**Reviewed by:  
Glenn Reese, P.E.  
Stormwater Engineer I  
glennreese@elpasoco.com  
719-675-2654**

**SMALL SUBDIVISION FINAL DRAINAGE REPORT  
FOR  
CLOVERLEAF FILING NO. 1**

**Project No. 25158.01**

**Add text:  
PCD Filing No.: SF-21-014**

### Stage-Storage Calculation

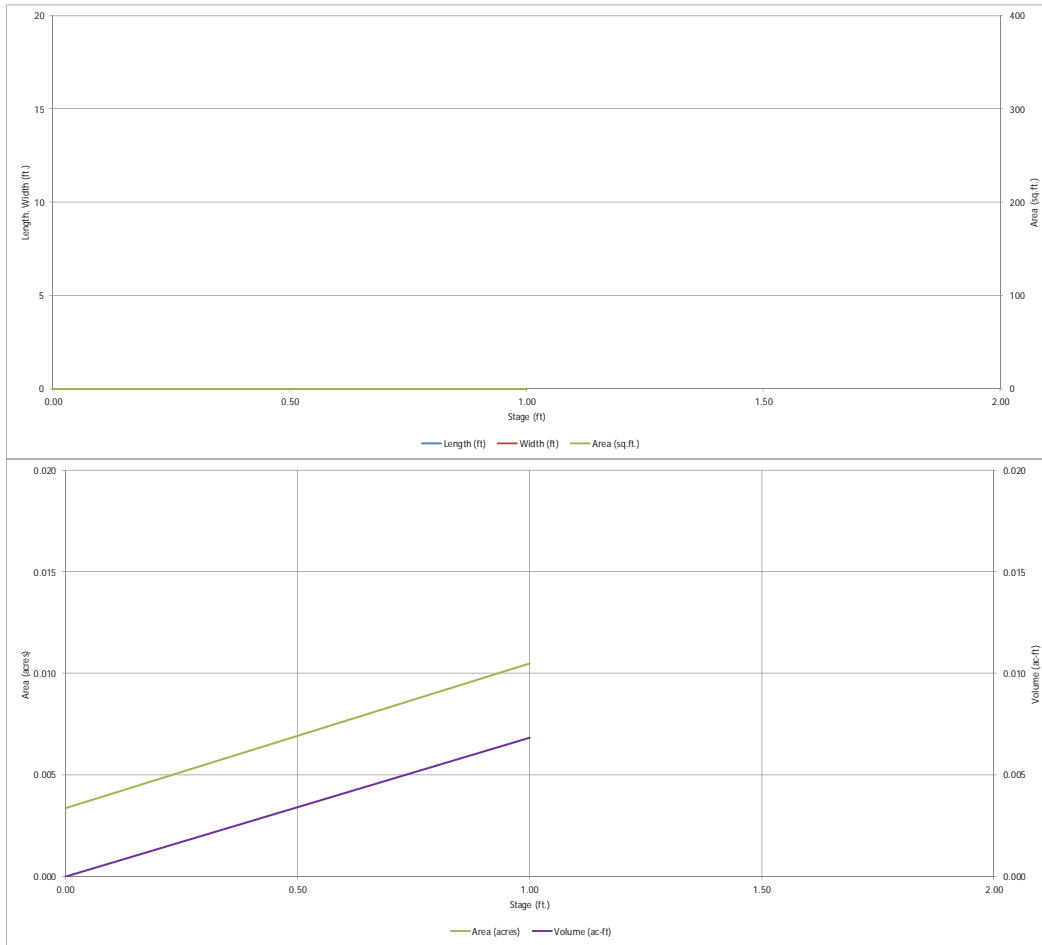
If applicable, input the overflow domed grate and 4" outlet pipe calcs into this sheet so all calcs are in one place.

### Routed Hydrograph Results

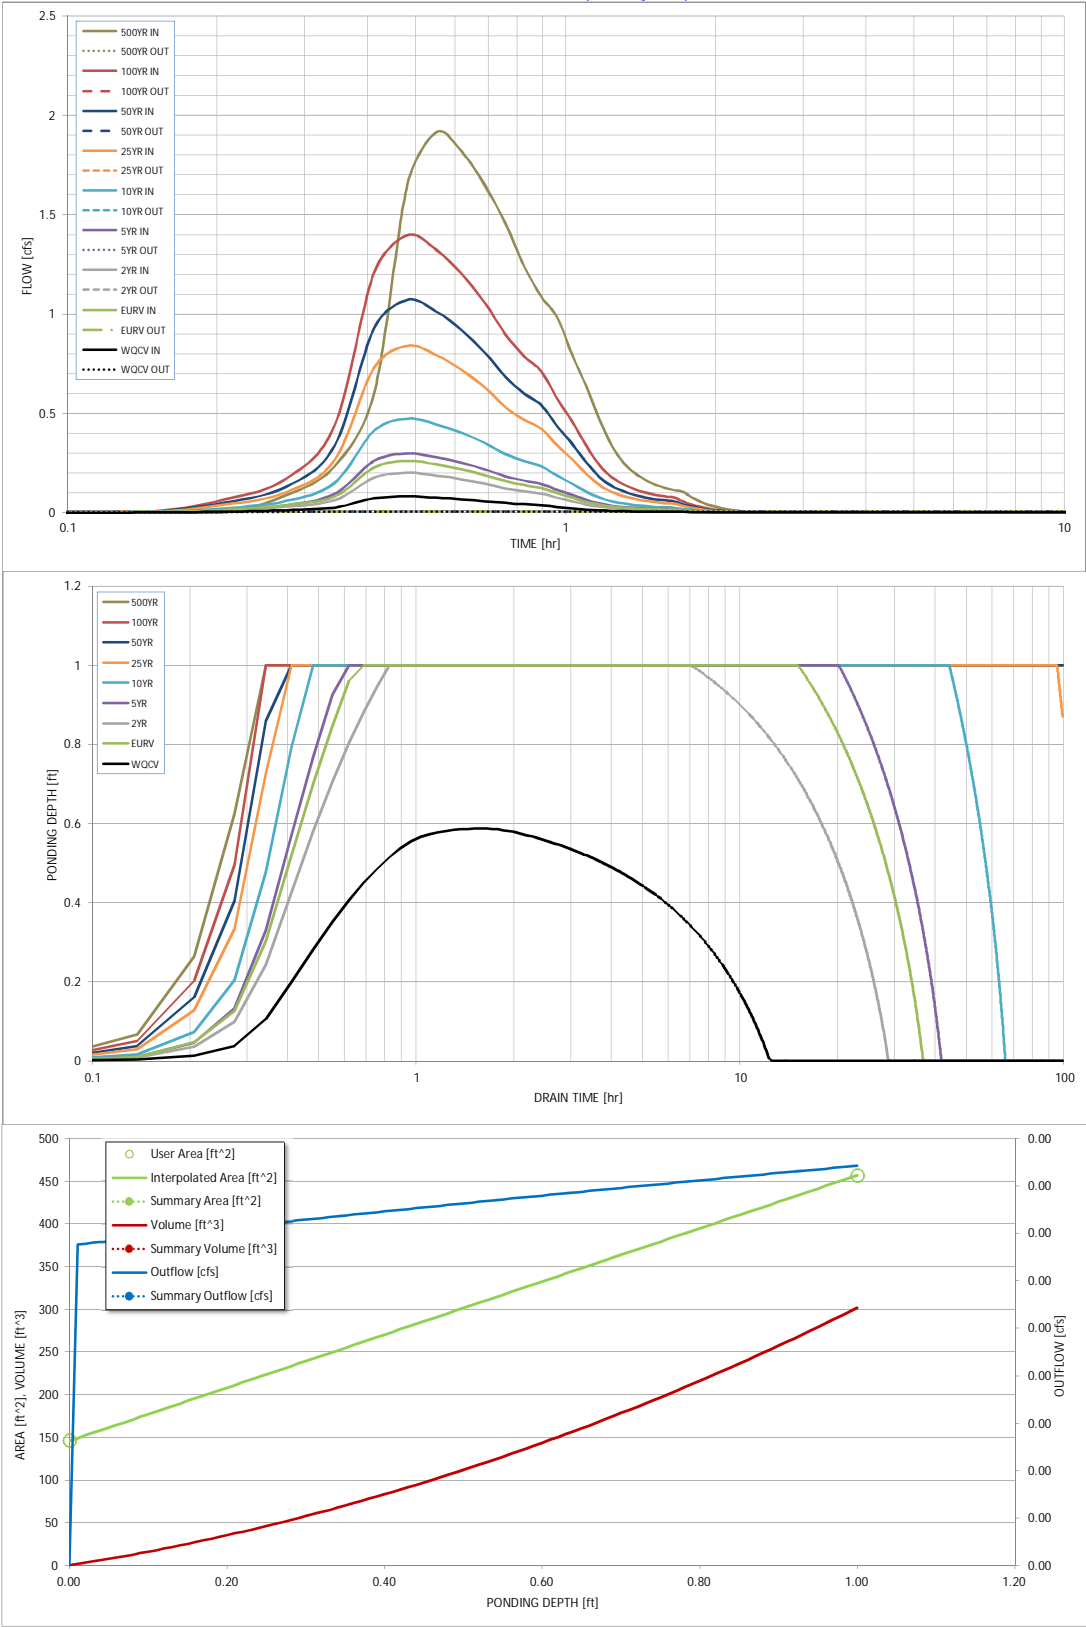
At depth of 1ft, the overflow grate (not filtration media) would be utilized up to 100-yr storm (according to calcs on page 49) and then the spillway for the 500yr. Revise accordingly for each SF.

From EURV to 500-yr storm, there is not much detention happening since the overflow grate is being utilized. For these storms, the inflow should almost equal the outflow. Meaning that the Peak Outflow for these storms should be greater than 0.0. Please revise.

SAND FILTER - PLAN VIEW

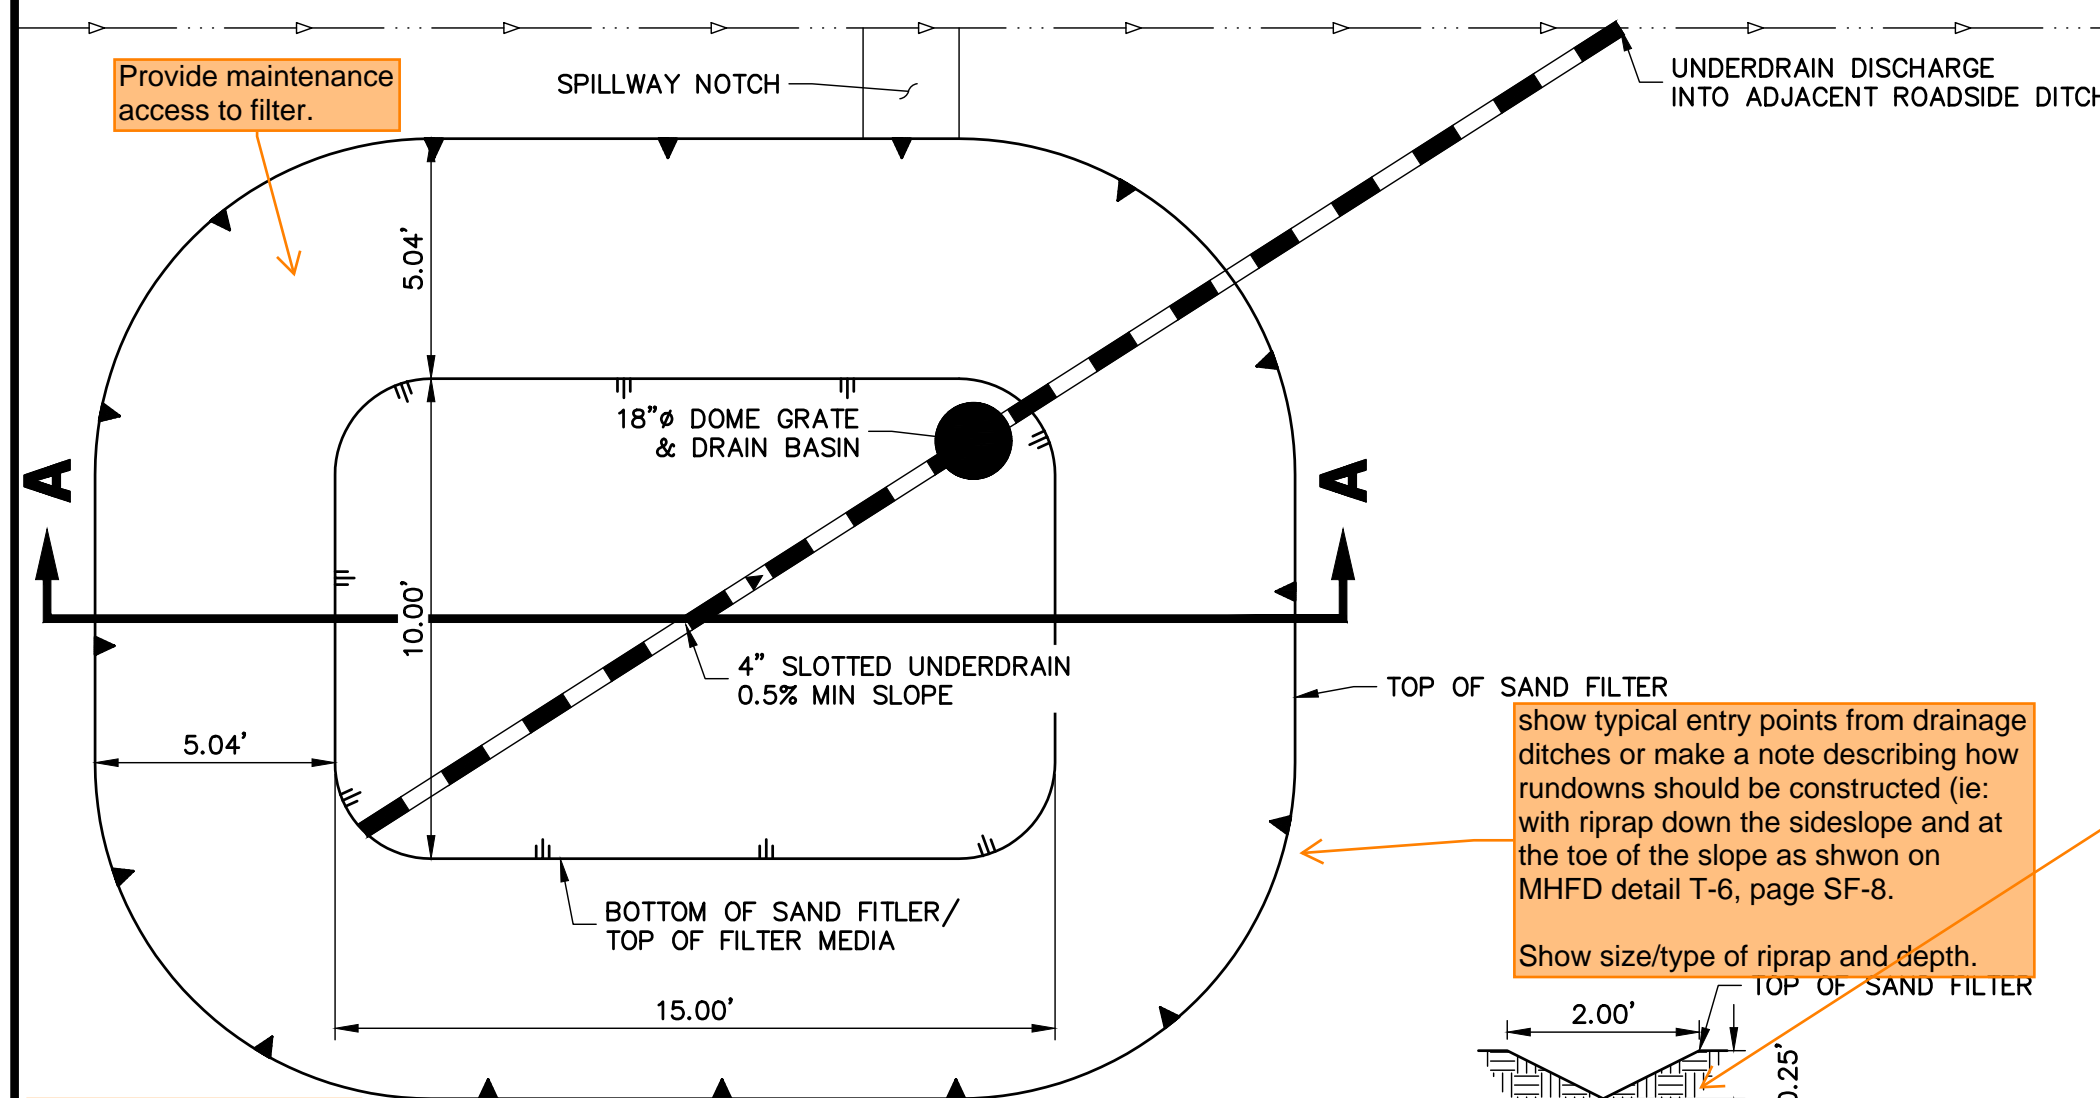
Per MHFD detail T-6, page SF-8, show a cleanout with 45deg elbows and cap.

SAND FILTER - SECTION A-A

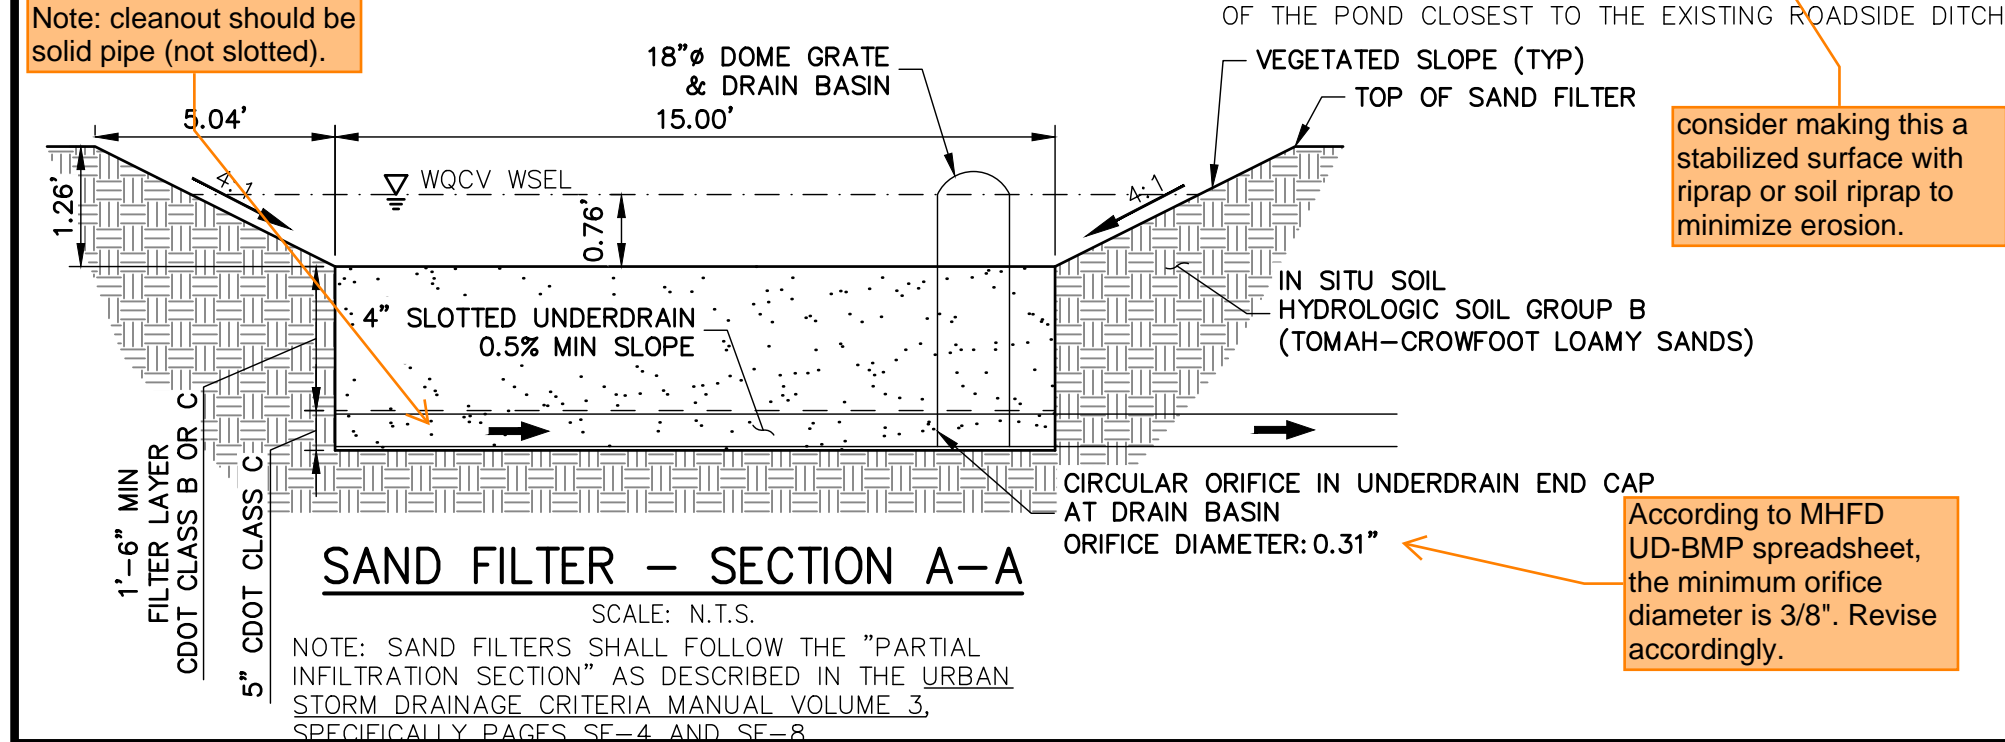
Note: cleanout should be solid pipe (not slotted).
